McIlwaine Subdivision Sketch Plan

PART 1: PROJECT SUMMARY

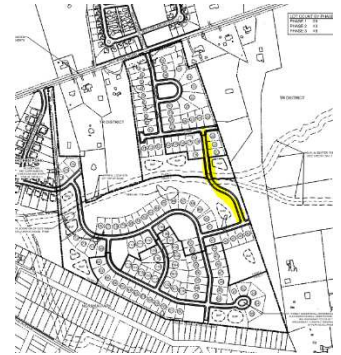
- The application is complete.
- Staff recommends approval of a waiver request for block length due to the topography and the nature at which the creek crossing occurs (see map to right for location).
- Staff recommends approval of the subdivision, once final comments have been made and the applicant makes corrections.

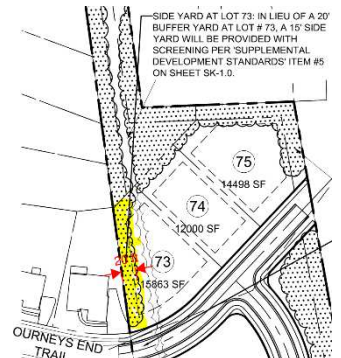
- 1) Open space calculations are incorrect and will not support the density requested. The urban open space parks are being counted as 1.5 larger than their actual area. The only opportunity to acquire 1.5X open space credit within this project is if the **developer builds, dedicates and the Town/County accepts the greenway**. The notes and open space calculations will need to be corrected to ensure the plan meets the ordinance.

- 2) A detail of the buffer reduction request along lot #73 is needed. The applicant is proposing 10' evergreen buffer (evergreen trees planted 30' on center and shrubs every 5' and a 15' building side yard setback). The ordinance requires a standard 20' undisturbed residential buffer. The Town Board does have the ability to waive or reduce the buffer, per Article 7, but at this time staff feels the intent of the ordinance is not being met.

- 3) An 80' buffer along existing state maintained roads (McIlwaine) is required to start at the proposed/future right-of-way. Due to the TIA not being vetted and NCDOT not commenting, there are road improvements that may need to be made thus requiring more right of way. If that is the case, the 80' buffer would need to be pushed back affecting the developments open space. Due to the lack of information on the plan staff cannot determine if the plan will meet the ordinance.

- 4) Minor plan revisions: note and labeling corrections need to be made on multiple plan sheets.

Subsequently the applicant has addressed all of the above.
